NUREG-2153  
Volume 1

# **Final Safety Evaluation Report for Combined Licenses for Virgil C. Summer Nuclear Station, Units 2 and 3**

Office of New Reactors

**Figure 2.4-3. Plant Site Drainage Basins and Flow Paths (FSAR Figure 2.4.-261)**  
 Subbasin 5 was designated by staff for examination of flow effects at the storm water basin in Subbasin 4

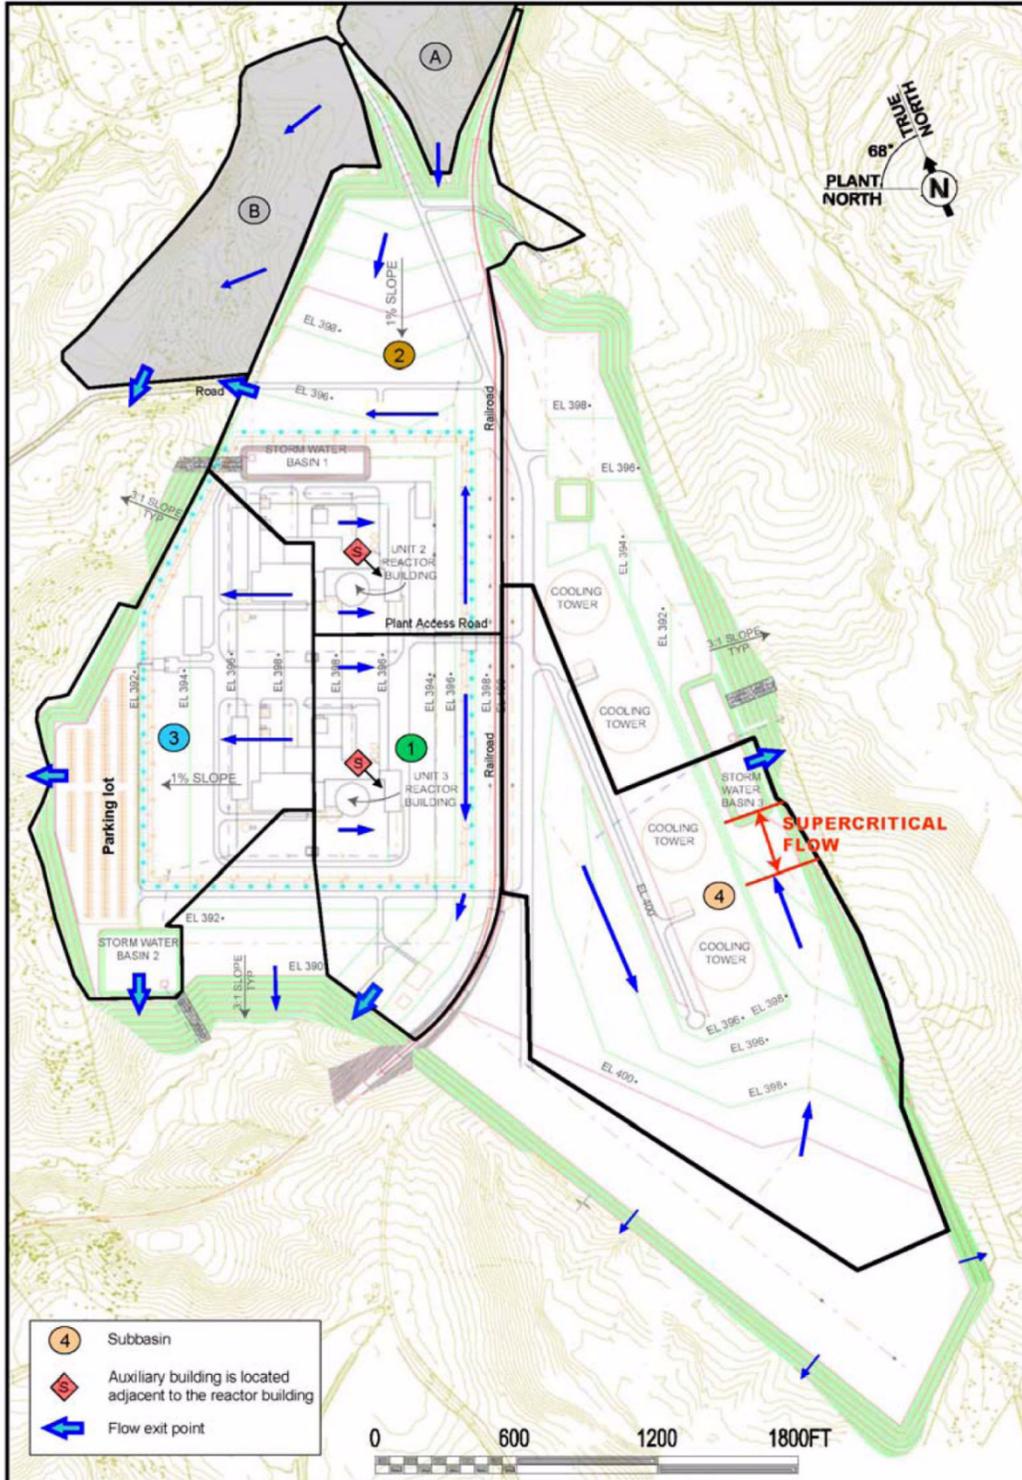
In the VCSNS COL FSAR, the applicant included the overall site map of the VCSNS site showing the plant site drainage basins and flow paths (FSAR Figure 2.4-210). The applicant's analysis used the HEC-RAS model to determine water surface elevations at the site. An important aspect of the HEC-RAS model is that it uses cross sections to define the geometry of the drainage area. A map with the locations of these cross-sections was not provided to the staff in the VCSNS COL FSAR. Therefore, in RAI 2.4.13-14, the staff requested that the applicant provide a map with HEC-RAS cross-sections and clear identification of the safety-related structures and the design basis flood elevation. Based on the basin map identified in RAI 2.4.13-14, the staff confirmed that the applicant's HEC-RAS model cross-sections adequately represent the drainage system in the site. In response to RAI 2.4.13-14, the applicant committed to add the cross-section map to a future FSAR revision, therefore, this will be tracked as **Confirmatory Item 2.4.2-1**.

The railroad line coincides with the flow divide for Subbasins 1 and 4. The power block area forms another significant divide for subbasins 1 and 3 as well as Subbasins 2 and 3. An additional drainage area (Subbasin 5) was used by the NRC for the examination of flow effects at Storm Water Basin 3 within Subbasin 4. This additional drainage area is depicted in SER Figure 2.4-3, "Plant Site Drainage Basins and Flow Paths."

Figure 2.5.1-1. Map of Physiographic Provinces and Mesozoic Rift Basins

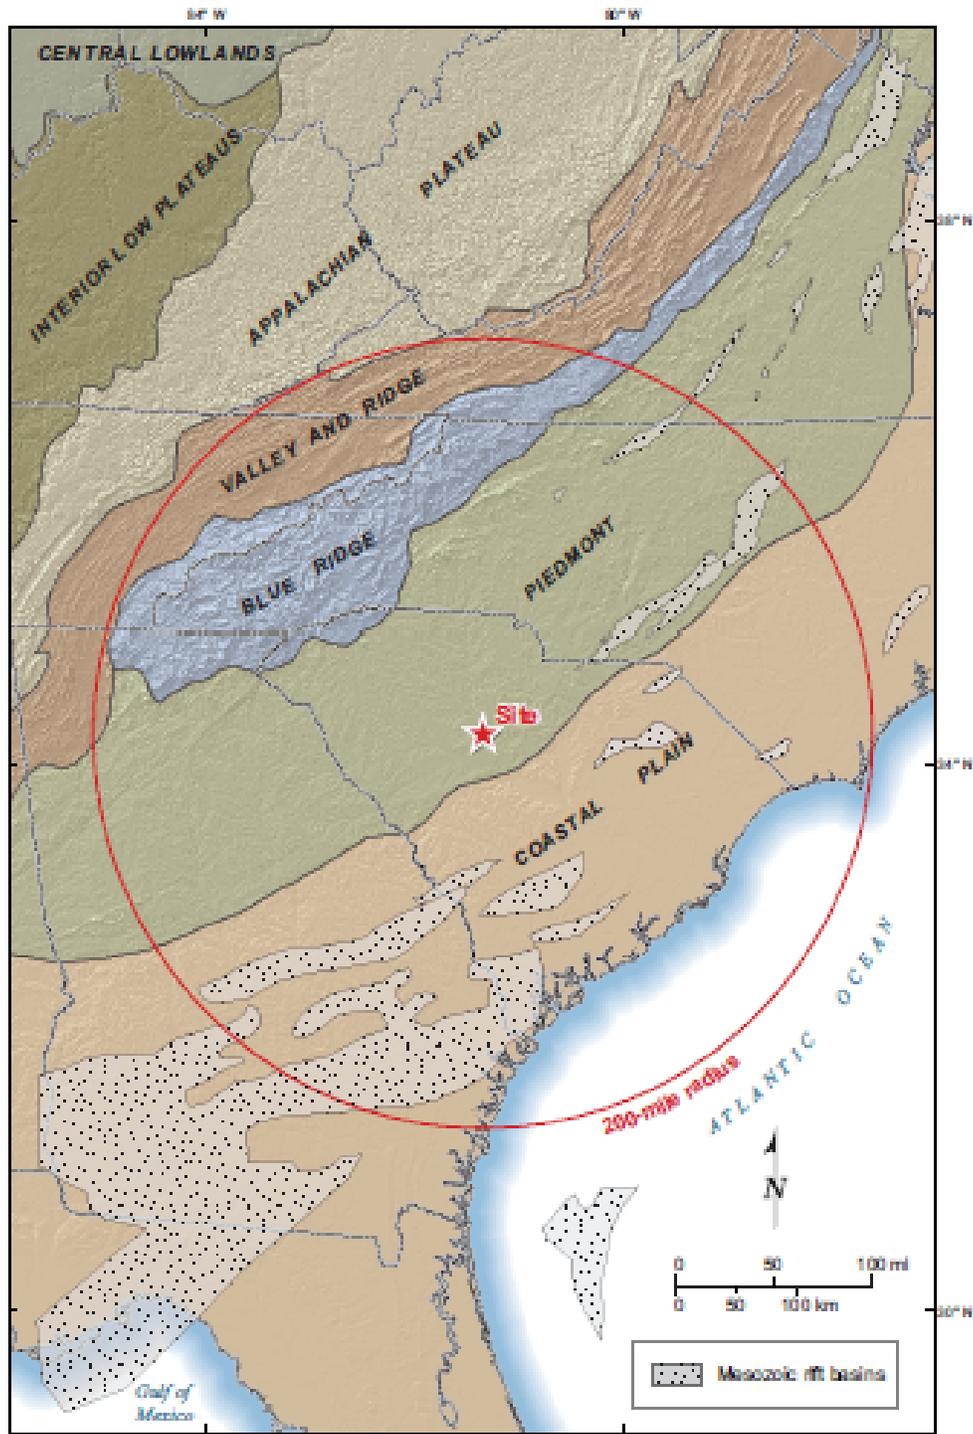
VCSNS COL FSAR Section 2.5.1.1.1 describes the regional physiography, geomorphology and stratigraphy in relation to the five physiographic provinces which occur in the VCSNS site region. SER Figure 2.5.1-1, reproduced from VCSNS COL FSAR Figure 2.5.1-201, shows the location of the VCSNS site and its spatial relationship to those portions of the Appalachian Plateau, Valley and Ridge, Blue Ridge, Piedmont, and Coastal Plain physiographic provinces within the site region. The VCSNS site is located in the Piedmont physiographic province.

In VCSNS COL FSAR Section 2.5.1.1.1, the applicant described regional physiography, geomorphology, and stratigraphy in relation to the five physiographic provinces which occur in the site region (SER Figure 2.5.1-1, reproduced from FSAR Figure 2.5.1-201). The applicant stated that the VCSNS site is located in the Piedmont physiographic province approximately 32 km (20 mi) northwest of its boundary with the Coastal Plain province (SER Figure 2.5.1-1), lying specifically in the Charlotte lithotectonic terrain of the Carolina Zone of the Piedmont province.

Figure 2.5.1-2. Potential Quaternary Features in the Site Region

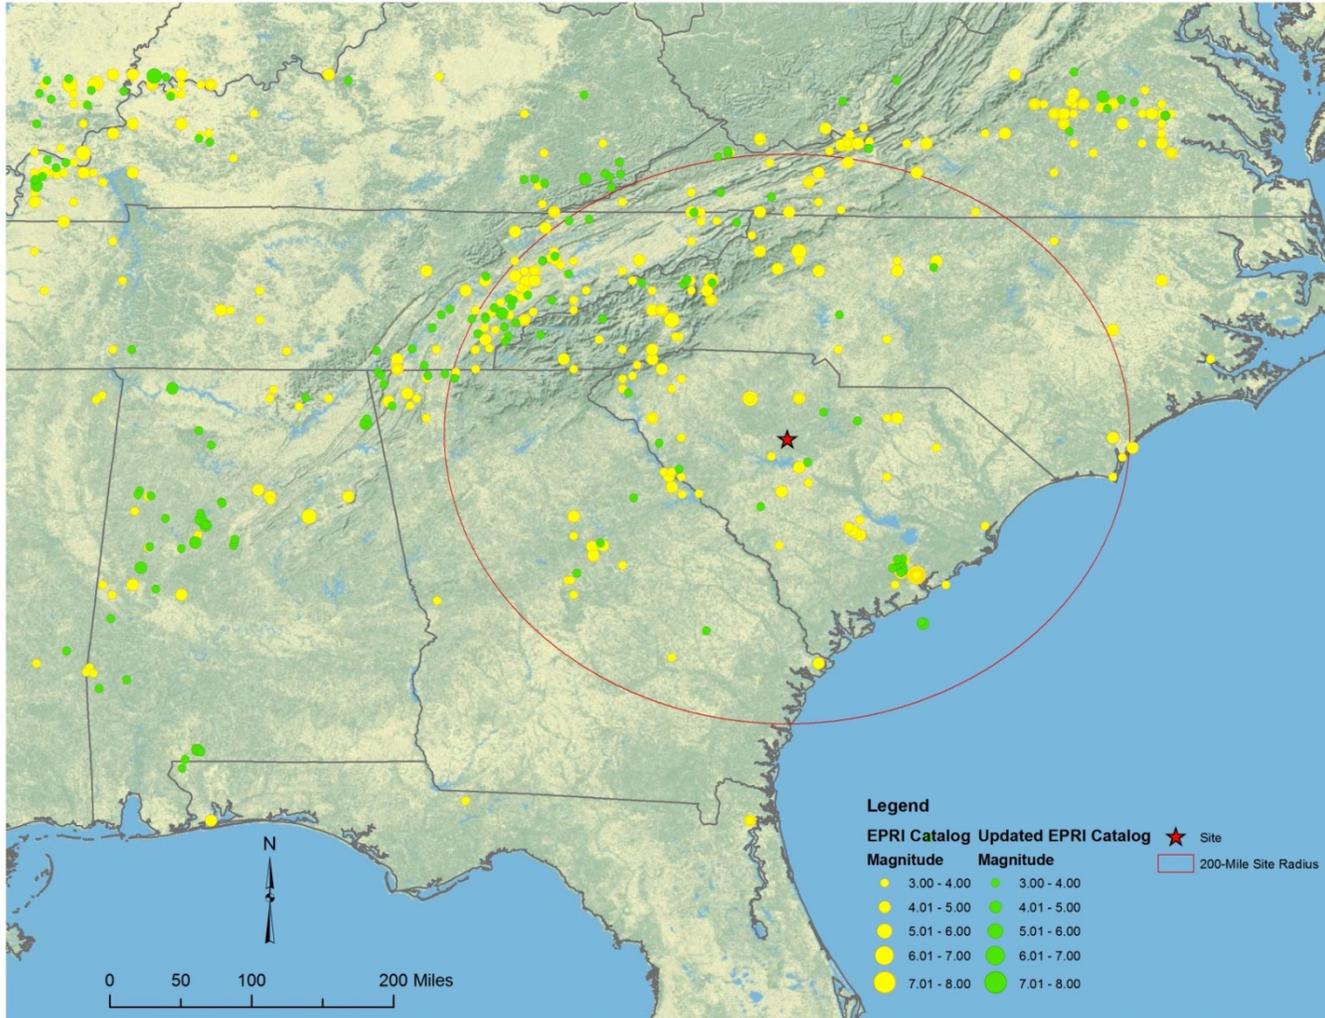
The applicant noted that the Pen Branch fault is more than 32 km (20 mi) in length and located 113 km (70 mi) south-southwest of the VCSNS site (SER Figure 2.5.1-2). The applicant stated that seismic reflection and borehole data collected at the Savannah River Site (Cumbest and others, 2000), as well as investigations performed for the Vogtle Electric Generating Plant (VEGP) ESP application (U.S. NRC, 2009), show no evidence of post-Eocene (i.e., < 33.9 Ma) deformation on the Pen Branch fault. Therefore, the applicant concluded that the Pen Branch fault is older than 33.9 Ma and is not a capable tectonic structure.

The applicant indicated that the Hares Crossroads fault was only recognized in a roadcut exposure approximately 320 km (200 mi) northeast of the VCSNS site (SER Figure 2.5.1-2). The applicant postulated that this feature likely resulted from land sliding, and is nontectonic in origin. Crone and Wheeler (2000) classified the Hares Crossroads fault as a Class C feature based on a lack of evidence for Quaternary (2.6 Ma to present) faulting.

Regional Quaternary Tectonic Structures. In VCSNS COL FSAR Section 2.5.1.1.2.4.4, the applicant listed 14 potential Quaternary (2.6 Ma to present) tectonic features which occur in the site region. Locations of the features are shown in SER Figure 2.5.1-2 (reproduced from FSAR Figure 2.5.1-215). Quaternary tectonic structures warrant the most detailed evaluation because the structures represent potentially capable tectonic features.

**Figure 2.5.2-2. UCSS Model**  
 (Reproduced from VCSNS COL FSAR Figure 2.5.2-213)

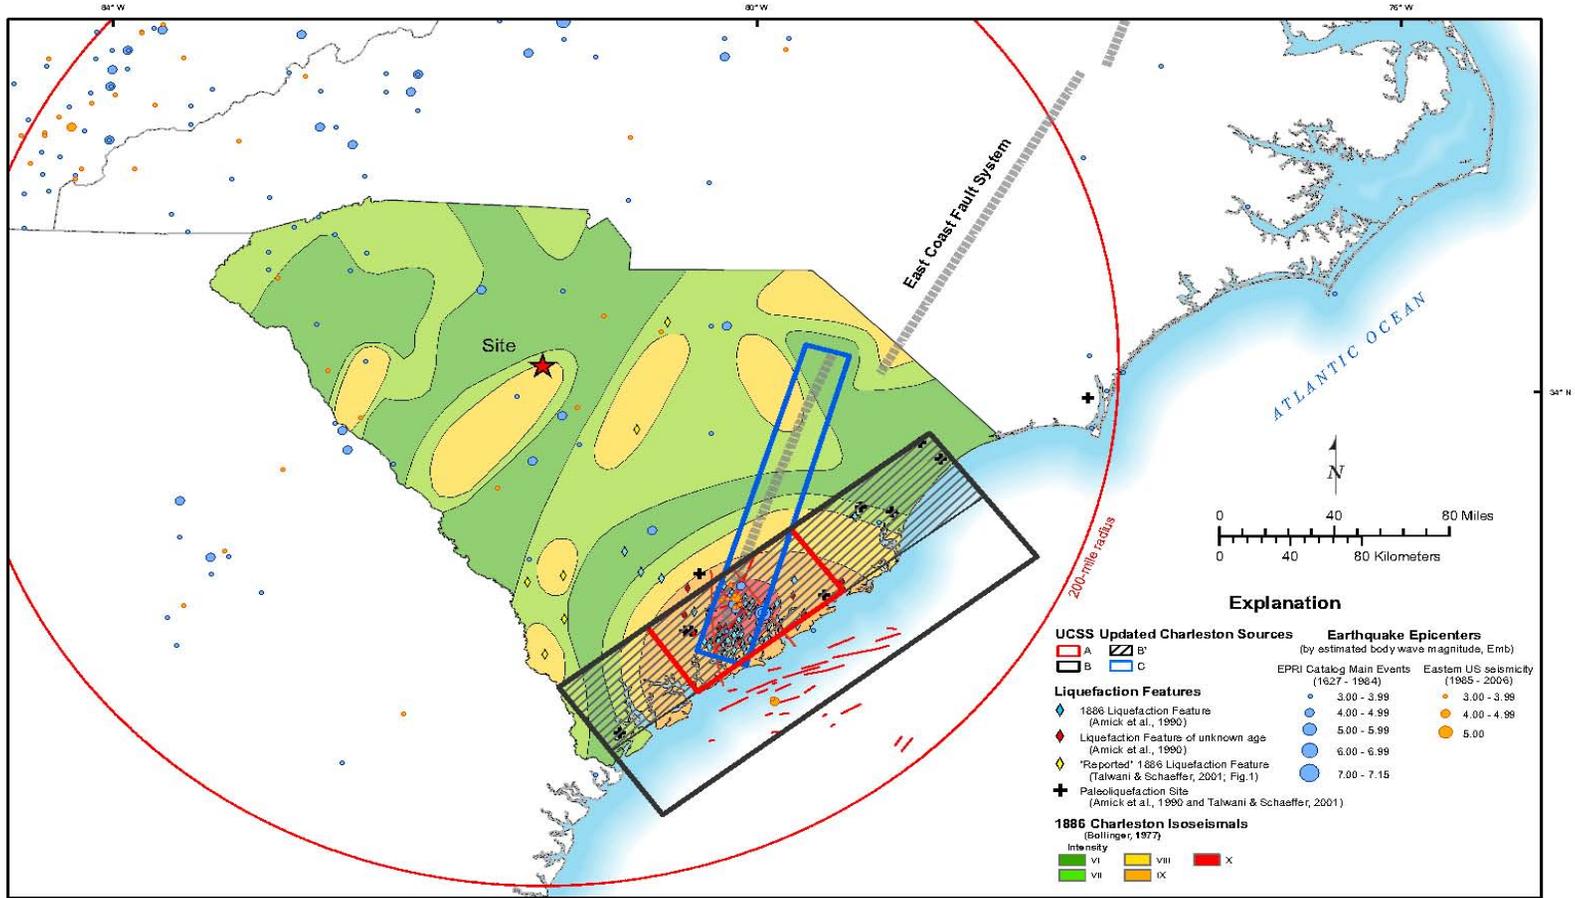
The applicant stated that the UCSS model includes four mutually exclusive source zone geometries and associated weights, referred to as A (0.7), B (0.1), B' (0.1), and C (0.1). These geometries, which are depicted in SER Figure 2.5.2-2, are based on: current understanding of geologic and tectonic features in the 1886 Charleston earthquake epicentral region; the 1886 Charleston earthquake shaking intensity; distribution of seismicity; and the geographic distribution, age, and density of liquefaction features associated with both the 1886 and prehistoric earthquakes. The applicant noted that Geometry A coincides with: the 1886 earthquake MMI X (severe damage) isoseismal (Bollinger 1977); the majority of identified Charleston-area tectonic features and inferred fault intersections; the area of ongoing concentrated seismicity; and the area of greatest density for the 1886 and prehistoric liquefaction features. Source zone B encompasses Geometry A and also extends beyond the Northeastern and Southeastern boundaries include paleoliquefaction features mapped by Amick (1990), Amick et al. (1990a, 1990b), and Talwani and Schaeffer (2001) and also extends offshore to include the Helena Banks fault zone. Geometry B' is identical to Geometry B, however it does not include the offshore Helena Banks fault zone. Geometry C envelops the southern segment of the ECFS as depicted by Marple and Talwani (2000).

**Figure 2.5.2-3. New Madrid Faults from the Clinton ESP Source Model**  
 (Reproduced from VCSNS COL FSAR Figure 2.5.2-217)

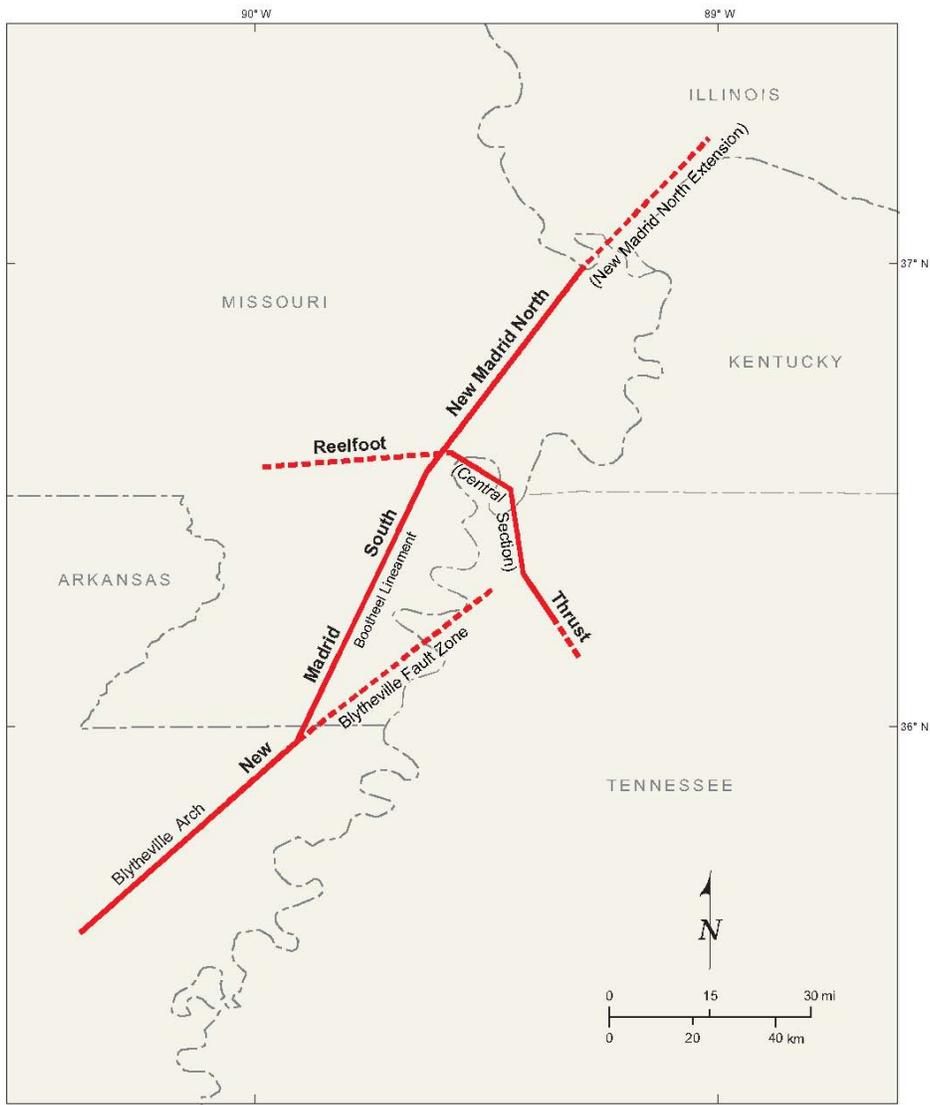
SER Figure 2.5.2-3 shows the New Madrid faults from the Clinton ESP source model. The applicant stated that the following three sources are identified in the NMSZ, each with two alternative fault geometries, which are provided in parentheses: Southern New Madrid (Blytheville arch/Bootheel Lineament, Blytheville arch/Blytheville Fault Zone); Northern New Madrid (New Madrid North, New Madrid North Plus Extension); and Reelfoot fault (Reelfoot Central Section, Reelfoot Full Length). The applicant stated that earthquakes in the NMSZ are treated as characteristic events in terms of magnitudes (similar to the UCSS model). The applicant stated that the magnitudes and weights for the New Madrid source faults (from the Clinton ESP model [Exelon, 2006]) are provided in VCSNS COL FSAR Table 2.5.2-221. The applicant noted that the characteristic magnitude ranges extend  $\pm 0.25$  magnitude units above and below the indicated magnitudes in FSAR Table 2.5.2-221.

**Figure 2.5.2-10. 10<sup>-5</sup> Hard Rock UHRS (Depicted by Red Circles) and 10<sup>-5</sup> High- and Low-Frequency Response Spectra (Depicted by Solid Blue and Dashed Green Curves, Respectively)**

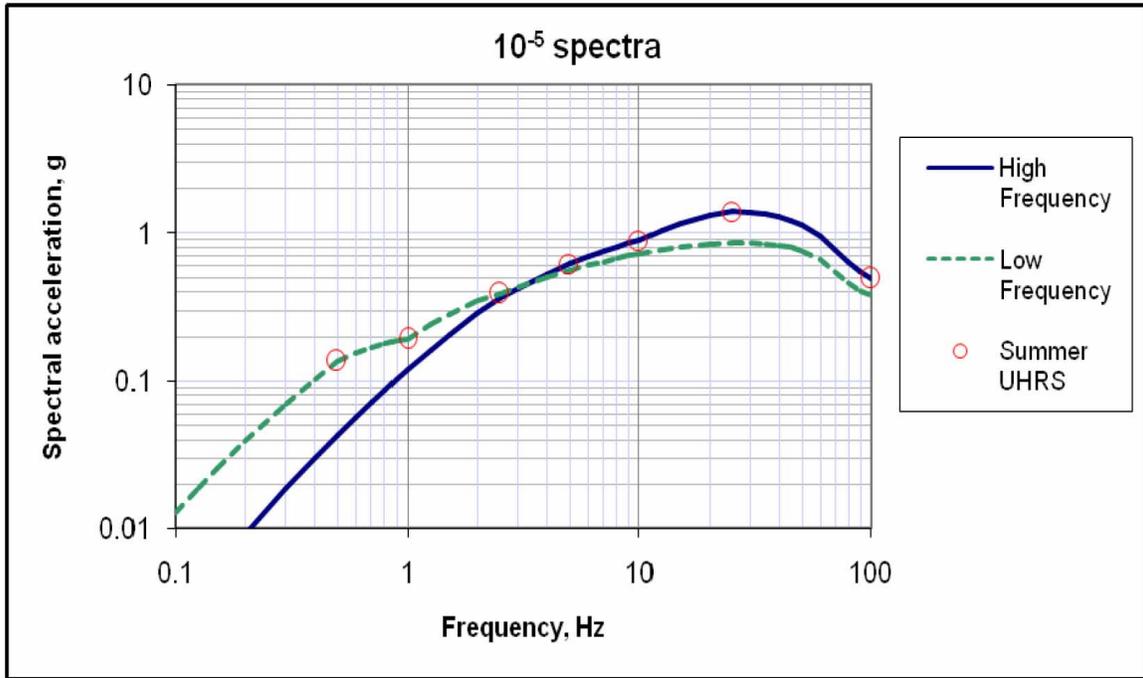
To develop the smooth  $10^{-5}$  UHRS, the applicant repeated the above process using the  $10^{-5}$  UHRS values from VCSNS COL FSAR Table 2.5.2-217, the controlling earthquake magnitude and distance values shown in FSAR Table 2.5.2-218, and the hard-rock spectral shapes for CEUS earthquake ground motions recommended in NUREG/CR-6728. The resulting  $10^{-5}$  high- and low-frequency spectra are shown in SER Figure 2.5.2-10. The applicant then developed the smooth  $10^{-5}$  UHRS from the envelope of the high- and low-frequency spectra shown in SER Figure 2.5.2-10.

Figure 2.5.3-1. 50-Mile Tectonic Features Map

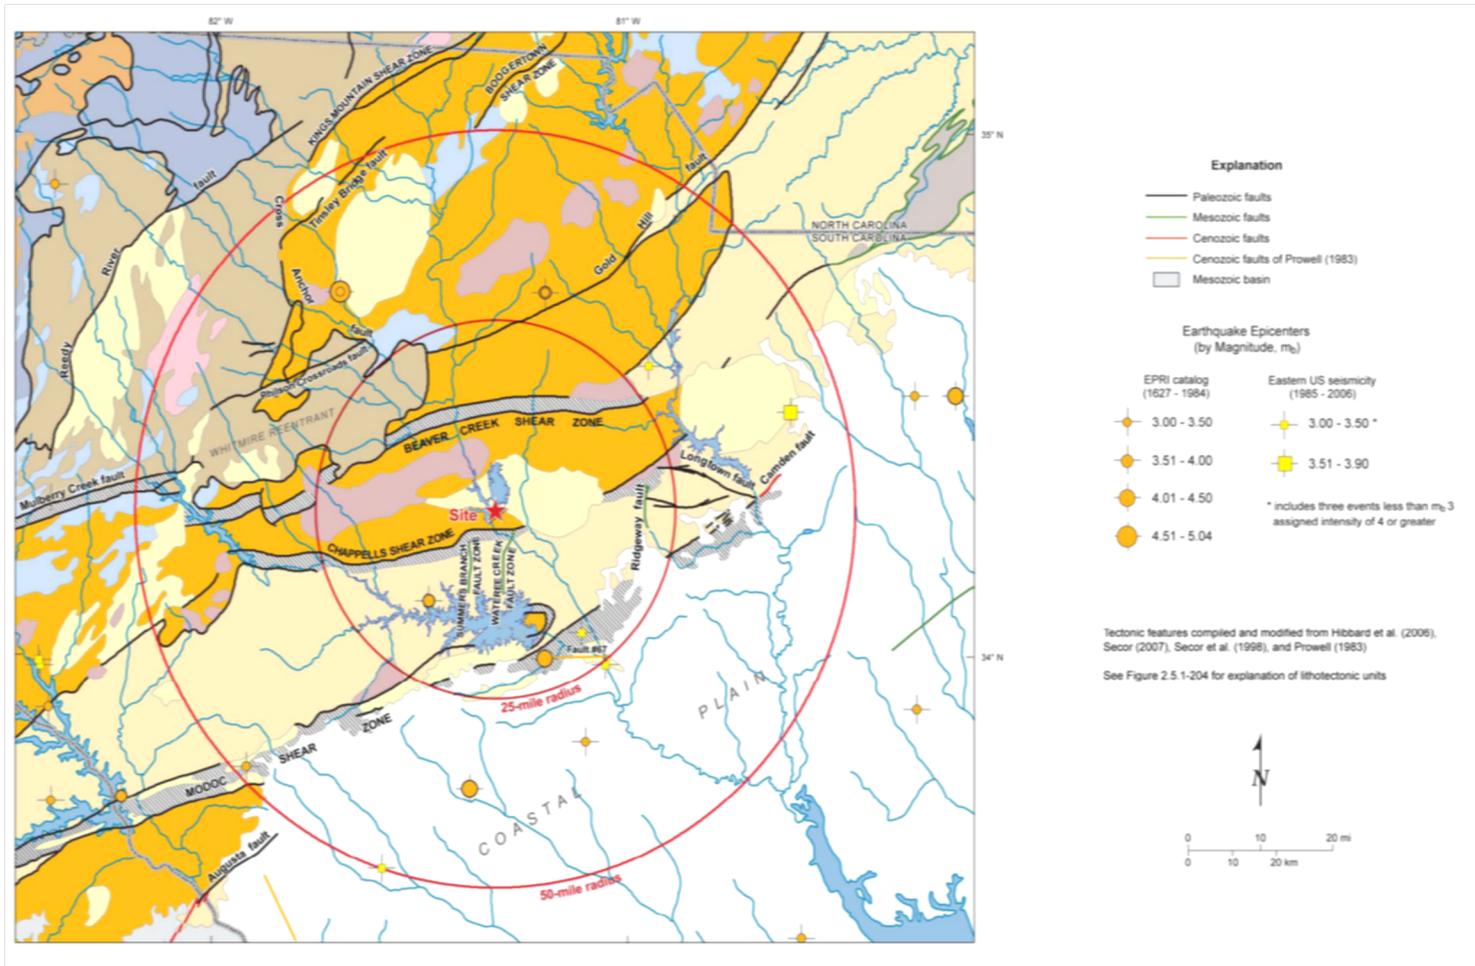
The following sections discuss the 12 bedrock faults and the geologic evidence used by the applicant to conclude that there is no Quaternary activity associated with any of these bedrock structures. SER Figure 2.5.3-1 shows the locations of these structures.
